_____ Red, bold, and italic comments were made during office processing.

Descriptive Report to Accompany Hydrographic Survey F00549

Project S-E926-NRT7-07
Hampton Roads, VA
Newport News Point
Scale 1:10,000
October 30-31, 2007 & January 17, 2008
NRT 7 (S3004)
Chief of Party: LTJG Briana Welton, NOAA

Figure 2. Two examples of a 0.3 meter horizontal offset in data acquired on January 17, 2008 (DN017).

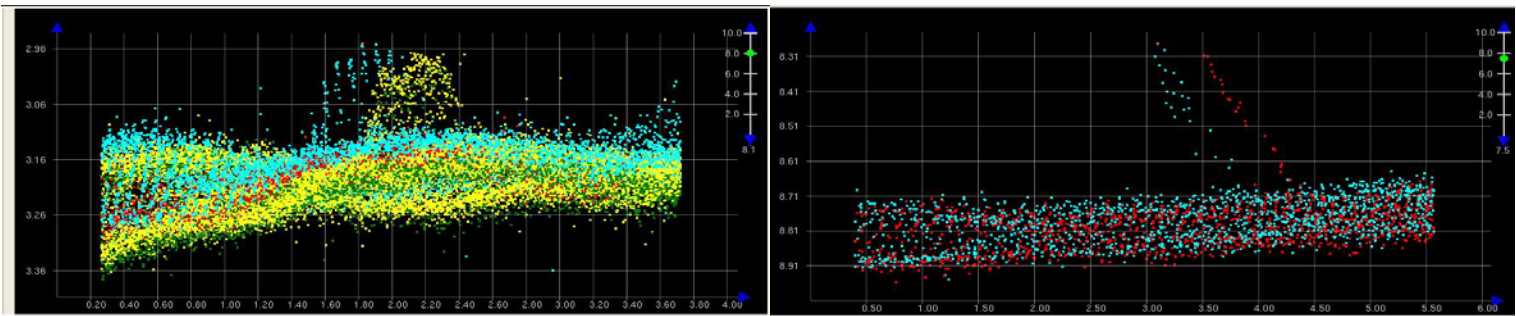
A horizontal offset of approximately 0.3 meters is present in data acquired on January 17, 2008 (DN017). This offset is illustrated by Figure 2. Vessel offsets and patch test values were checked in the HVF and were found to be correct. The hydrographer attributes this offset to loose positioning during the time of acquisition. Though unattractive, this offset is within position standards of the NOS Specifications and Deliverables for Hydrographic Surveys. *Concur.*

Figure 4: Charted survey area before and after DTON submission.

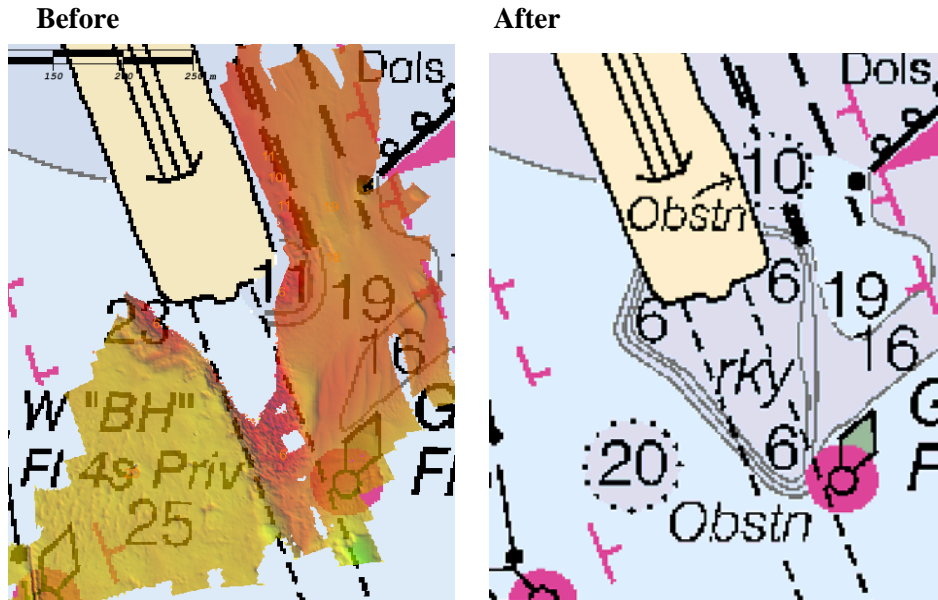
The area south of the bridge-tunnel interchange is surrounded by riprap. Three dangers to navigation were issued in an attempt to define the riprap area. Figure 4 is a side-by-side before-and-after comparison of the chart before the DTONs were applied. **Concur.**

Figure 4. Sewer Line.

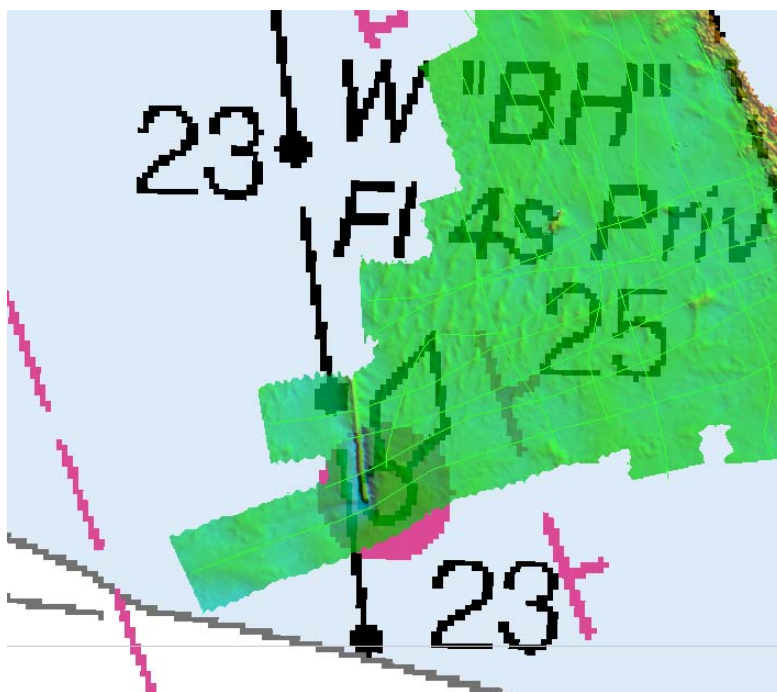
One sewer line runs through the western side of the Newport News Creek entrance area, and is clearly visible in the bathymetry. The sewer line appears to be correctly charted in the area common with F00549 as shown in Figure 4. *Do not concur. Actual location of feature is slightly east of charted location. Recommend to MCD to update position.*

Figure 5. Sand wave areas.

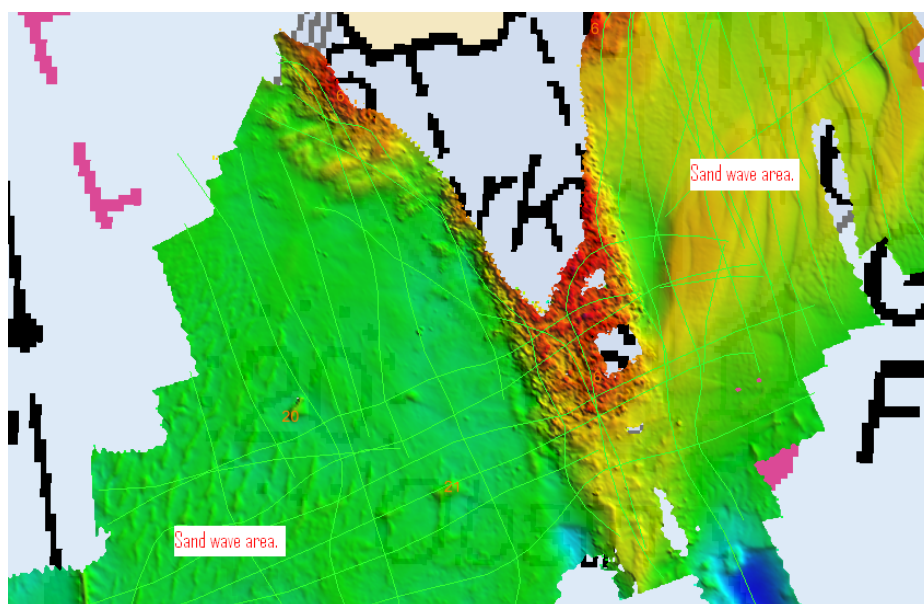
Sand waves of varying degree are evident in the bathymetry around the bridge tunnel interchange (see Figure 5). *Concur.*

Figure 1.1.1

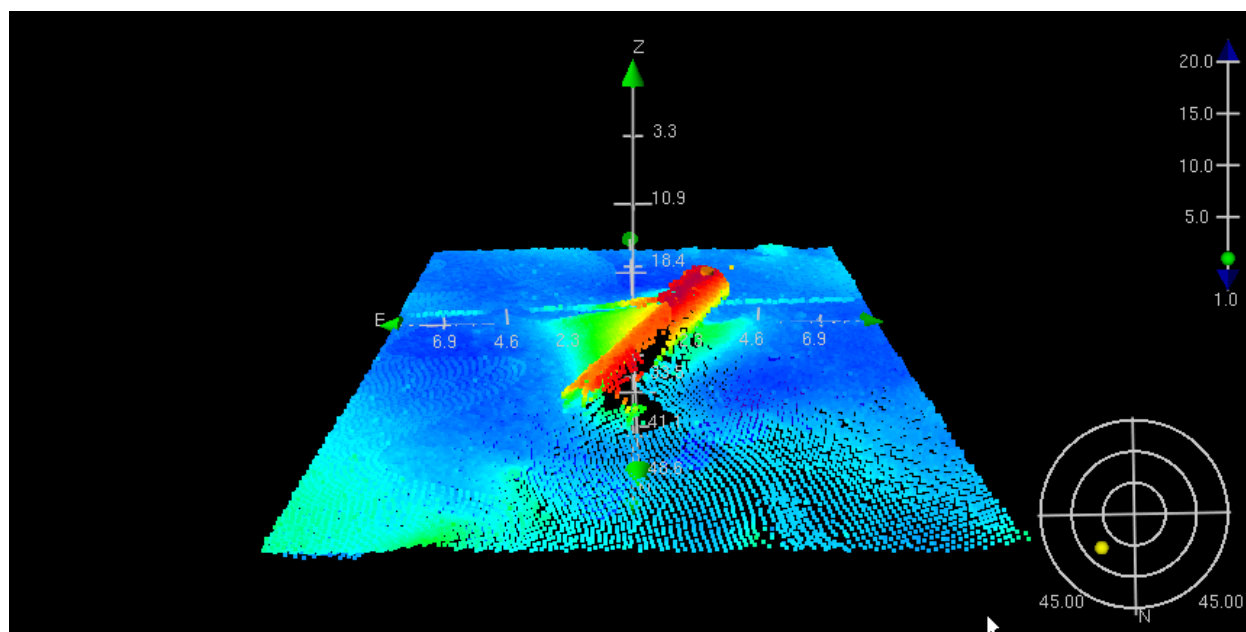
pipe

Chart obstruction.

Concur with clarification. Feature was charted as result of DtoN letter submission. Retain feature as charted.

Figure 1.2.1

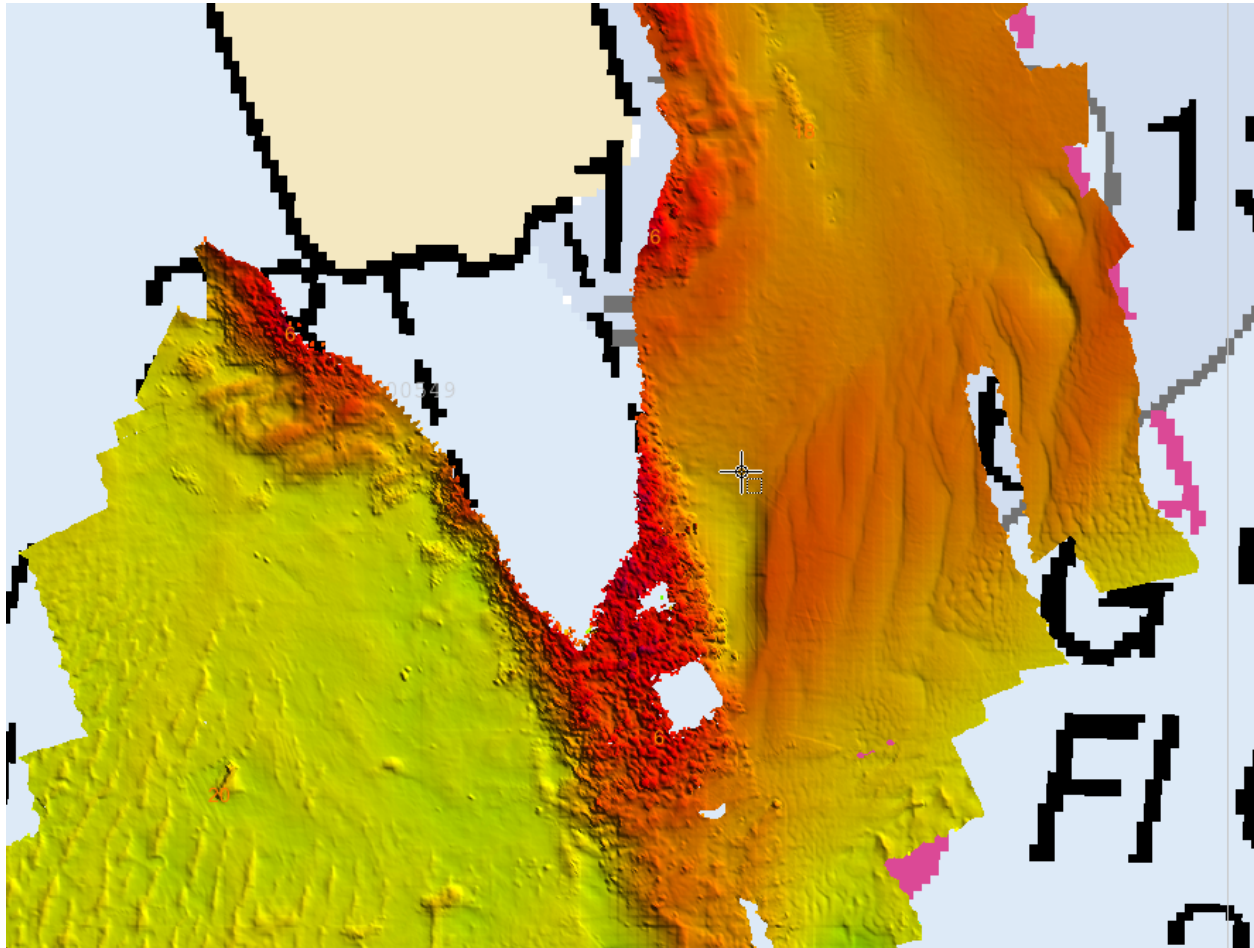
NW extent riprap area adjacent tunnel bridge.

Chart least depth, or add riprap area around tunnel bridge as depicted by data.

Concur with clarification. This 6-foot depth was charted as a result of a field-submitted DtoN letter. This 6-foot depth, two other nearby 6-foot depths, and a 'rky' were charted to indicate the extents of a riprap area. Retain as charted.

Figure 1.3.1

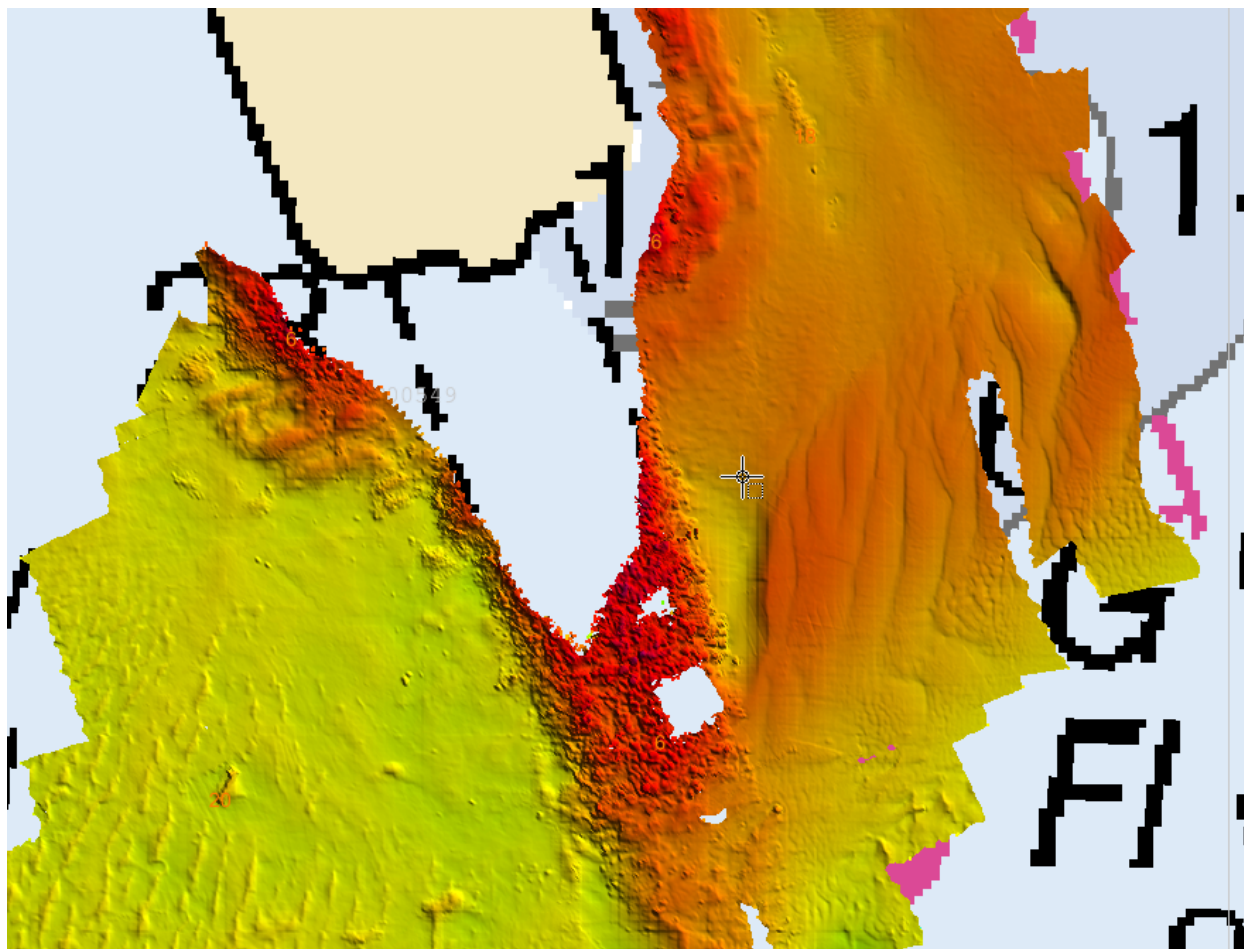
southern extent submerged riprap from tunnel bridge

Chart least depth, or add riprap area around tunnel bridge as depicted by data.

Concur with clarification. This 6-foot depth was charted as a result of a field-submitted DtoN letter. This 6-foot depth, two other nearby 6-foot depths, and a 'rky' were charted to indicate the extents of a riprap area. Retain as charted.

Figure 1.4.1

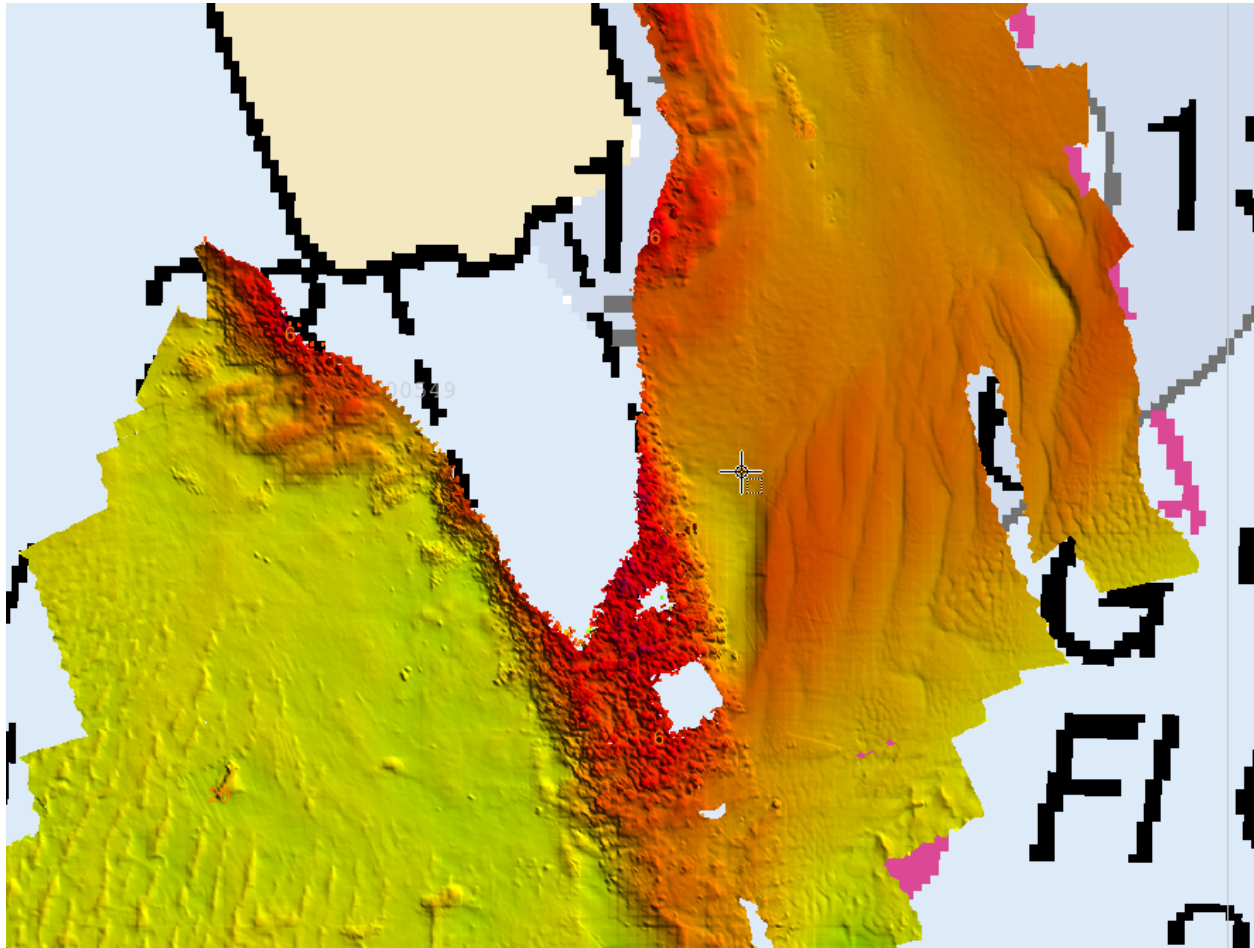
NE extent rip rap around tunnel bridge.

Chart least depth, or add riprap area around tunnel bridge as depicted by data.

Concur with clarification. This 6-foot depth was charted as a result of a field-submitted DtoN letter. This 6-foot depth, two other nearby 6-foot depths, and a 'rky' were charted to indicate the extents of a riprap area. Retain as charted.

Figure 1.5.1

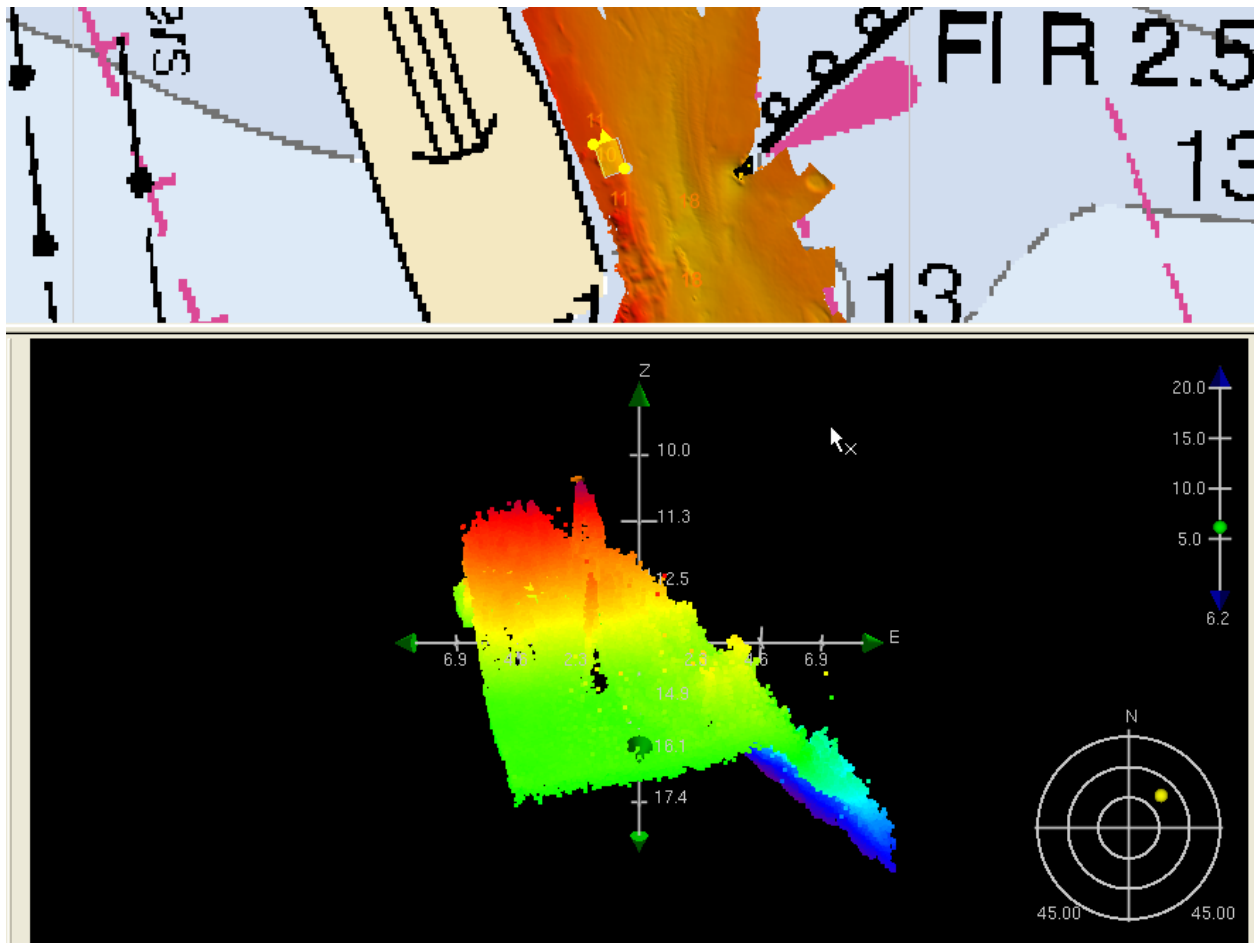
debris along bridge

Chart least depth.

Concur with clarification. Item was charted as a result of DtoN letter submission. Retain as charted.
